Ref: 20100623-turbines
Date: 23 June 2010

WIND TURBINE WAKE PLUME
VELOCITY DEFICIT AND TURBULENCE

As per our latest telephone conversation I agreed to write a letter that you can present to the Victorian Review Panel handling the Stockyard Hill Wind Farm Application Number PL-SP/05/0548.

**Beaufort (Hawkwood)
YBFT**

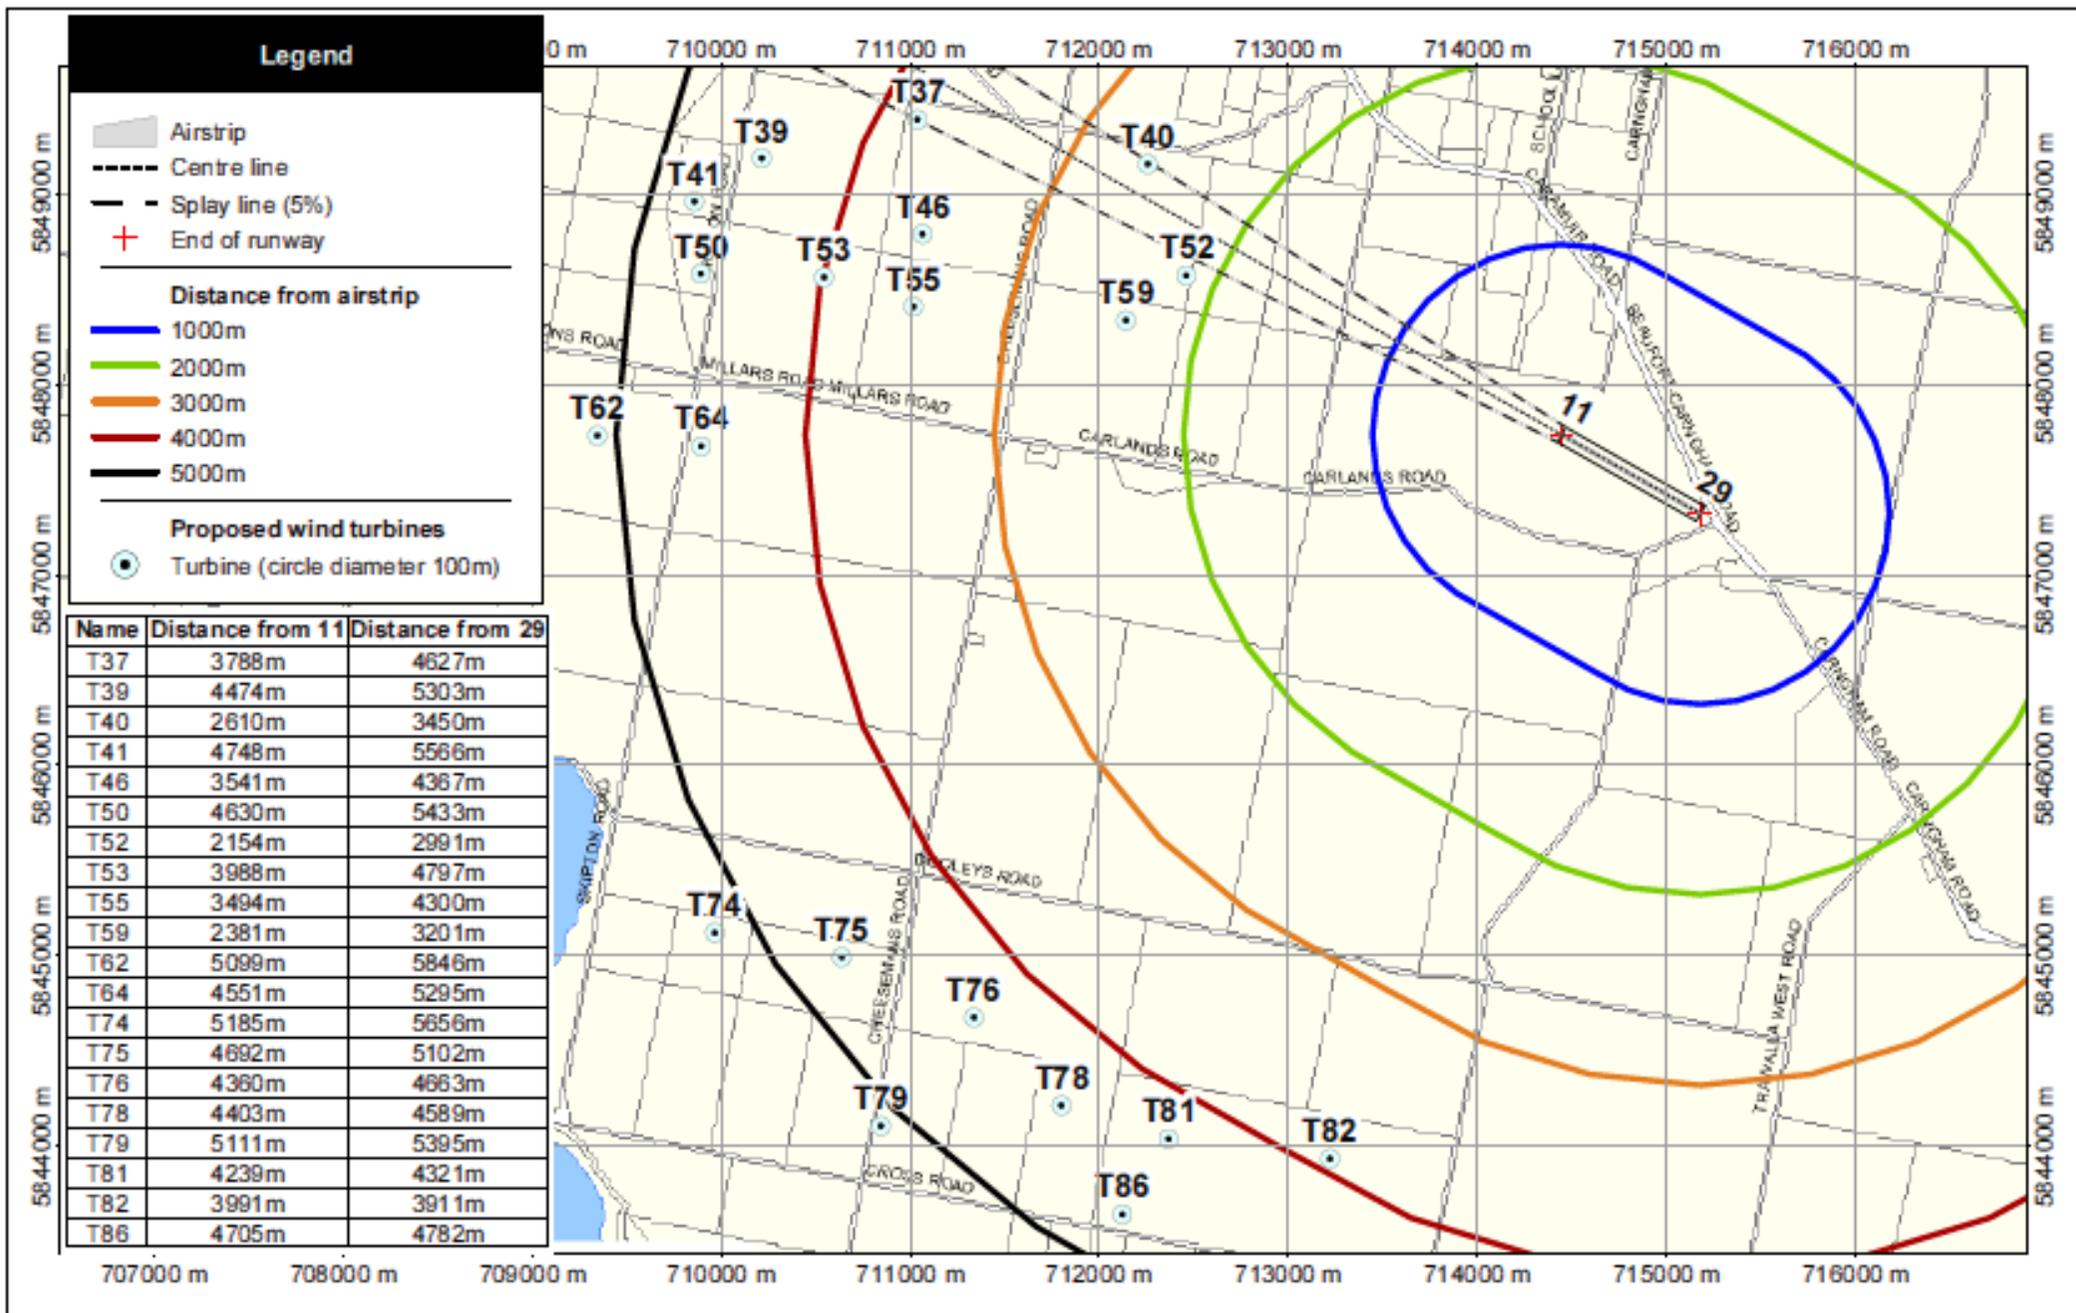
With the information supplied from you that the strongest prevailing winds are typically from the North West, West and South West directions, and then surveying the turbine proposed locations on your operational area map, I can see two clusters of turbines that will directly affect your ALA operational area to varying degrees of extent, namely the clusters : T40, T52, T59, T37, T46, T55, T53, T39, T41, T50, T64 and T62 for direct take-off and landing, and clusters: T75, T76, T78, T81, T82, T74, T79 and T86 which will affect crosswind operations.

Thus I would argue for an operational area of 4920 meter radius from the runway threshold for Category B aircraft and a setback of turbines from this operational area of 50 blade diameters. This represents an additional 5200 meters for turbines with the proposed 104 metres blade-tip diameter.
